WILTON PUBLIC WORKS
DEPARTMENT

RE: 131 Danbury Road, Wilton CT – 131 Danbury Wilton Dev AMS, LLC

This letter is written in response to the review of the submission by Redniss & Mead dated November 17, 2023 for the proposed development on 131 Danbury Road and other miscellaneous items submitted. Based on the review of the above mentioned application at this time, the items listed below shall be addressed:

SITE PLAN - UTILITIES
PROPOSED MULTI-FAMILY DEVELOPMENT
 131 DANBURY ROAD
 WILTON, CONNECTICUT

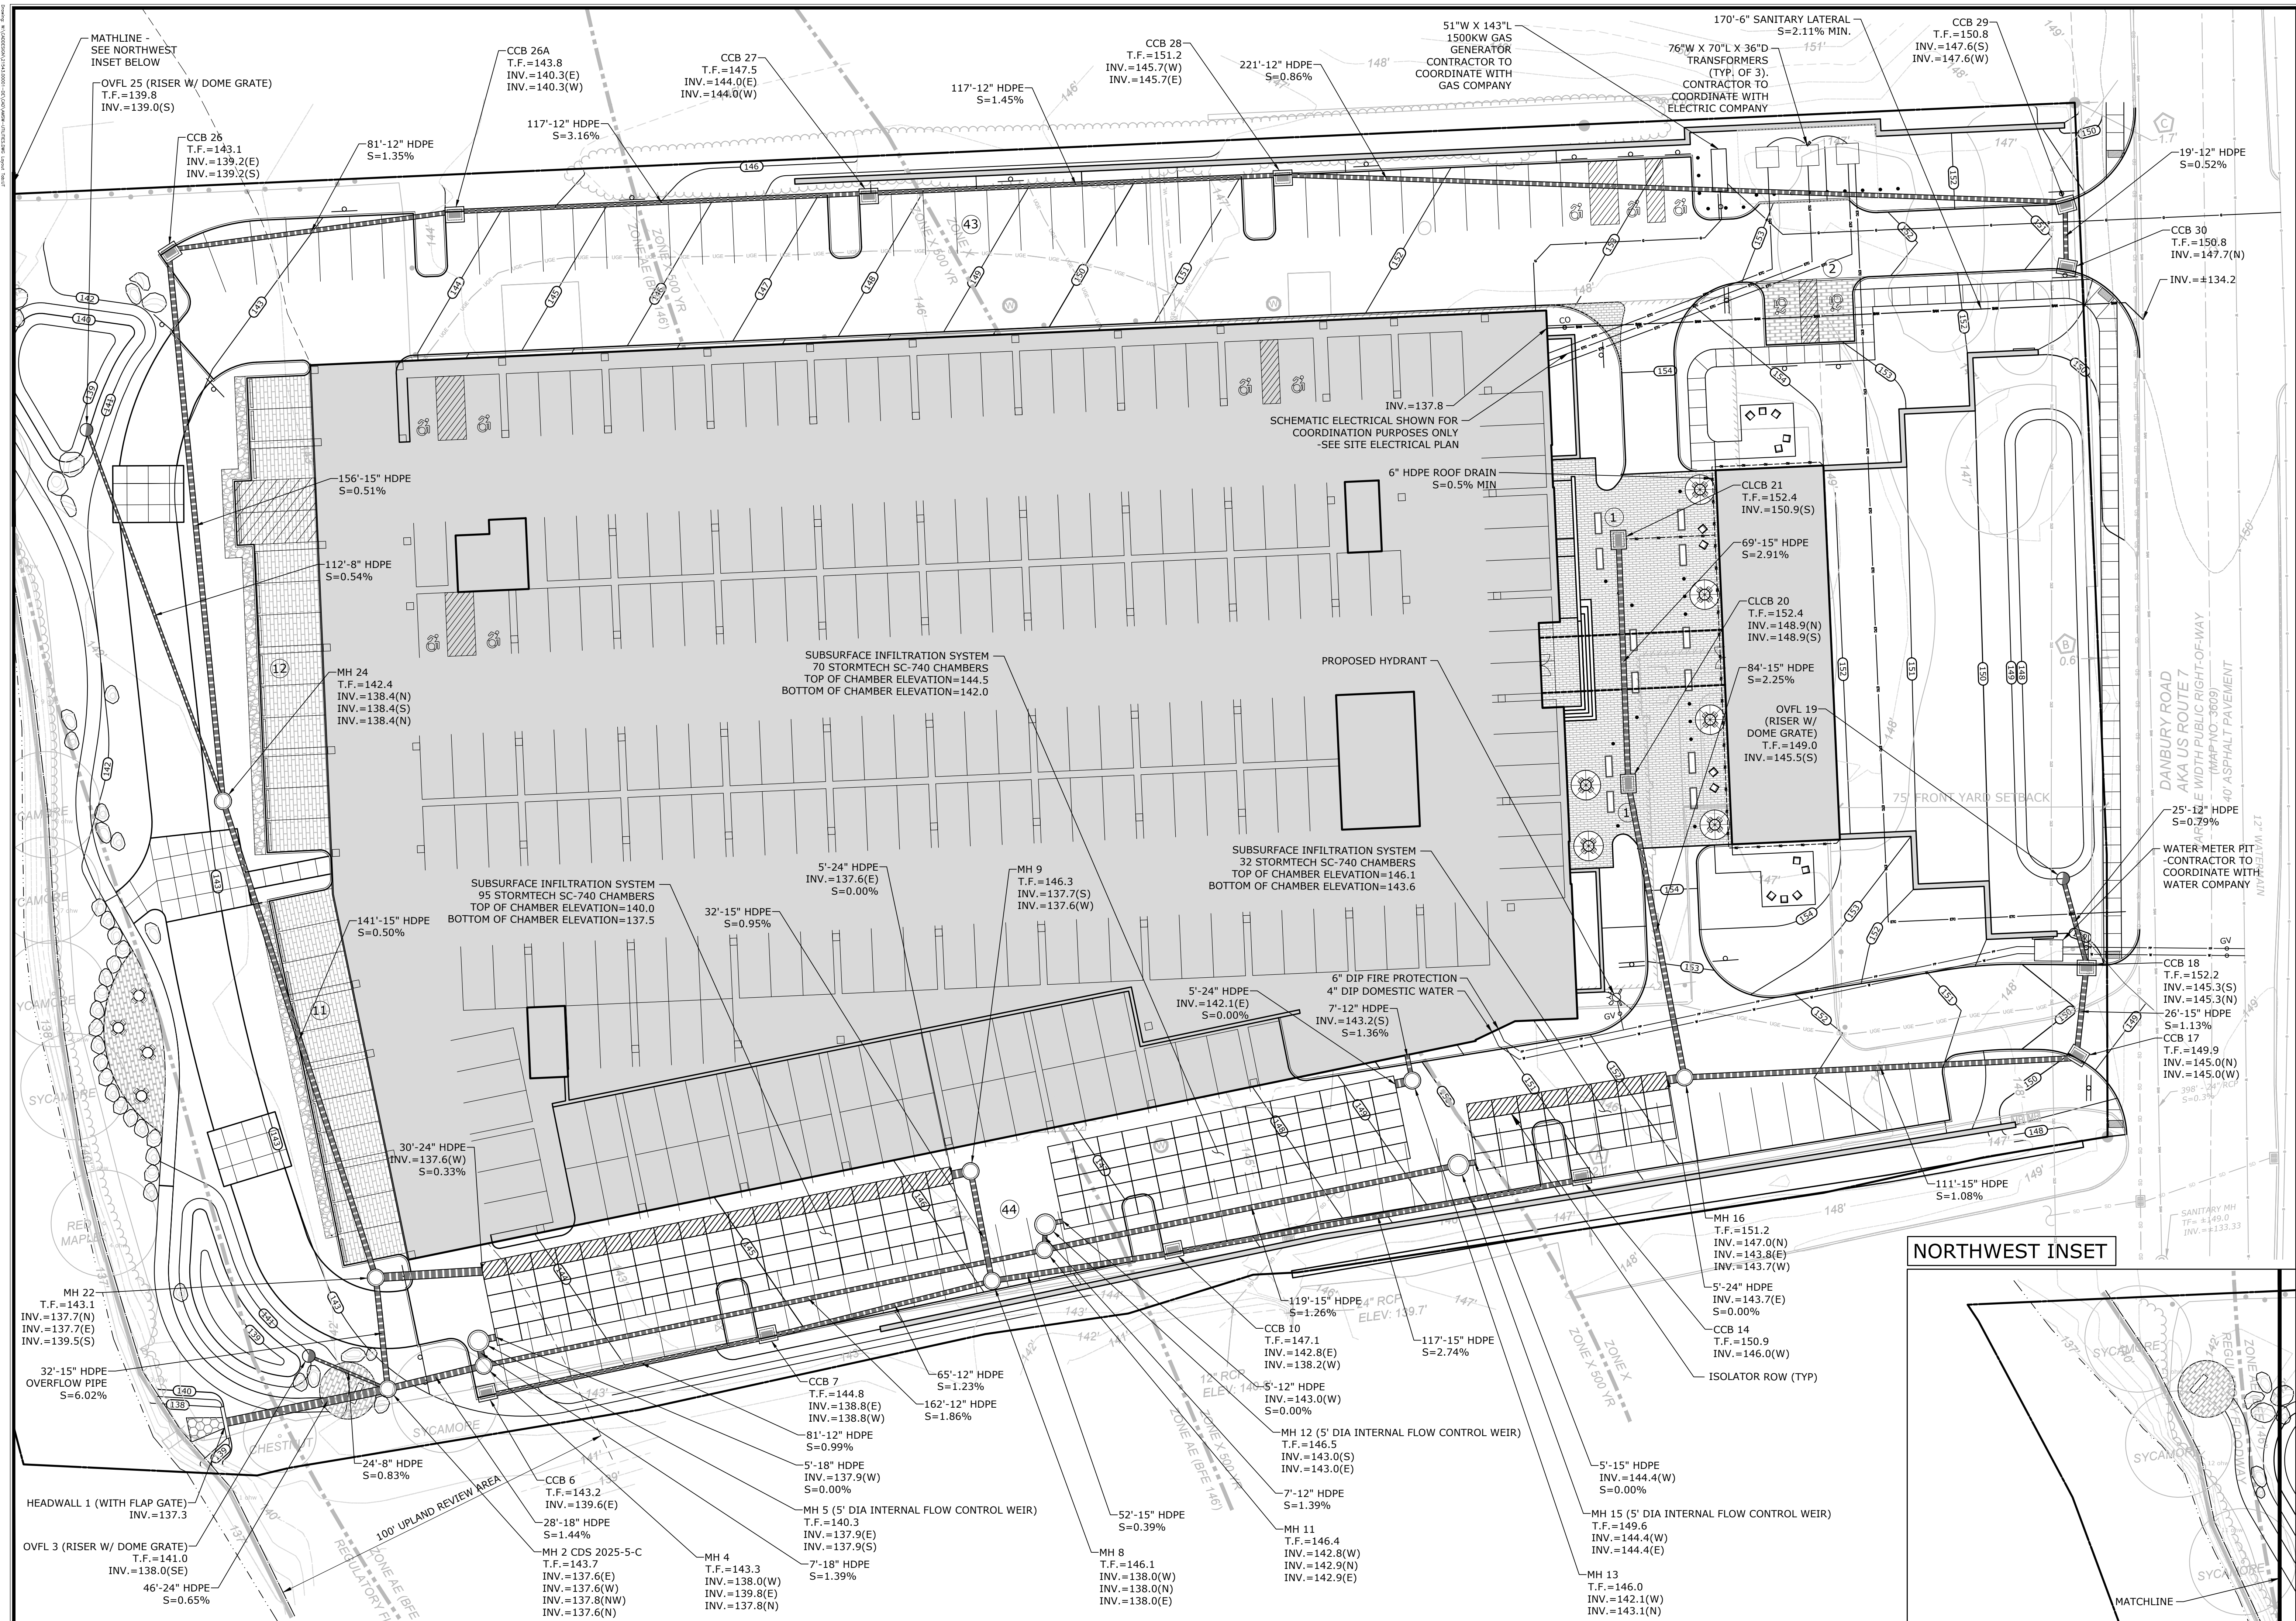
- 4) Design Engineer shall address Norwalk WPCA's review as per email dated 11/28/23.
All items shall be addressed prior to signoff of building permit
- 5) Engineer to evaluate the use of an 8" sewer line. The proposed sewer lateral shall be connected to a new manhole along the existing sewer main within Route 7. Modify details.
Addressed – final details/plans shall be reviewed prior to signoff of building permit

- 4) Design Engineer shall address Norwalk WPCA's review as per email dated 11/28/23.
- 5) Engineer to evaluate the use of an 8" sewer line. The proposed sewer lateral shall be connected to a new manhole along the existing sewer main within Route 7. Modify details.

4. Calculations were provided indicating that a six-inch pipe has sufficient capacity to accommodate peak flows from the proposed building. However, given the comment from the Norwalk WPCA, the lateral size has been changed to an eight-inch diameter as indicated on the updated plan dated January 5, 2024. Also indicated on the updated plan is a manhole at the connection point to the sewer main in the street.
5. See item 4 above.
6. No drains in the parking area below the building are proposed or required.

Included herewith for your consideration is the updated Site Utility Plan and Site Details by SLR revised through January 5, 2024.
